**Application Reference - 11 Rosslyn Hill
Civil Engineering Dynamics Ltd report ref AKS/3400/R1/iL dated 1st February 2016
"Structural and Ground Dynamics"**

Alan Baxter Ltd (ABA) are appointed by Mr and Mrs A Jeffreys, the owners of No. 11 Rosslyn Hill, to provide structural engineering input in relation to their proposal to form two new basement areas as extensions to their existing basement. ABA have provided advise on the best structural engineering practice for basement development to the Royal Borough of Kensington and Chelsea and Westminster City Council which has informed the development of their planning policies in relation to residential basements. We have also designed and advised on many basement developments throughout London. We act for the Crown Estate in respect of basement proposals put forward by their leaseholders. We have advised Crossrail on the impact of tunnelling works on all of the listed buildings along its route and have worked for many years on some of our nation's most important buildings. We have all of the requisite skills and experience to deliver this project technically. We have a reputation for the high standard for our engineering work. We have

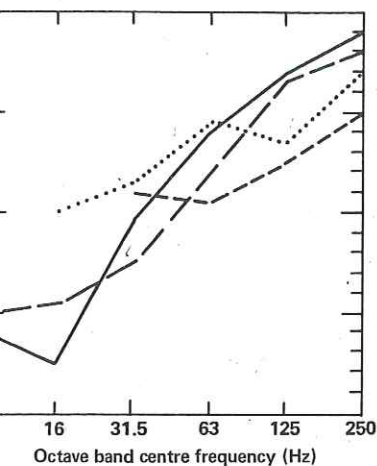
In this case however the screening benefit to main studio would not be perceived by the main studio because the dominant sound path from the train tunnels would continue to be the nearer direct path. With the other smaller studios they are on isolated bearings and so there is currently no noise impact. That will continue to be the case with the TV room basement constructions present.

The effects of this screening I refer to can actually be seen in the readings by Civil Engineering Dynamics, the noise levels from the further northern line tunnel being around 3dBA less than the nearer tunnel. That 3dB attenuation can be expected to be mostly due to the closer tunnel acting as a noise screen to the second tunnel, the differences in distance between the two being unsubstantial, (and hence the additional distance attenuation).

Figure 2: Approximate ground movement due to installation of underground swimming pool adjacent to the vaulted main studio of Lyndhurst Hall

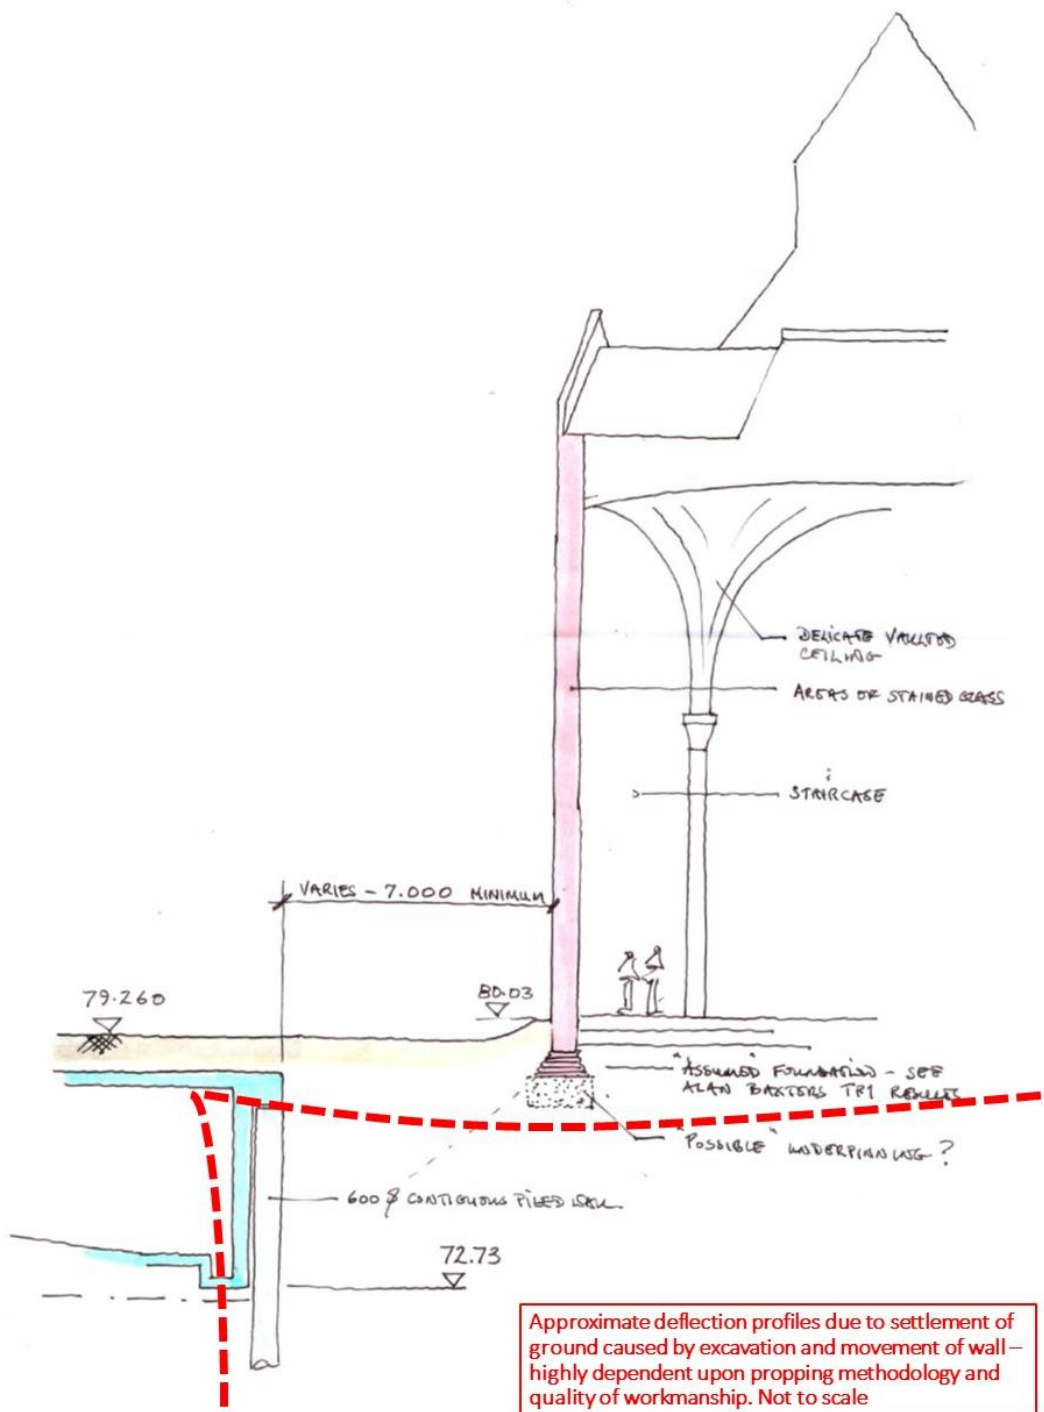
Contained within the BIA is a crack assessment using the Burland scale, related to the length of Lyndhurst Hall, following a process set out in a CIRIA technical guide; however, no consideration has been given to ground movements, horizontal or vertical, on the stability or cracking of the triple height vaulted roof structure of Lyndhurst Hall main studio. See figure 2 below for an approximate assessment we have sketched out based on the limited information to hand.

It is well known that the Burland damage assessment procedure cannot be used on its own as a direct measure of damage to property yet this is the only approach used in the BIA.

C&T sketch (figure 2) indicates an “approximate deflection profile due to settlement of the ground”. The profile drawn would be consistent with an unproped excavation. This is not what is proposed and is misleading. For the section of basement indicated in C&T’s Figure 2 a ‘top down’ construction methodology is proposed. This involves casting the roof slab before carrying out the excavation and acts as a very stiff prop to the top of the retaining wall throughout the construction process. The deflection profile shown is therefore incorrect.
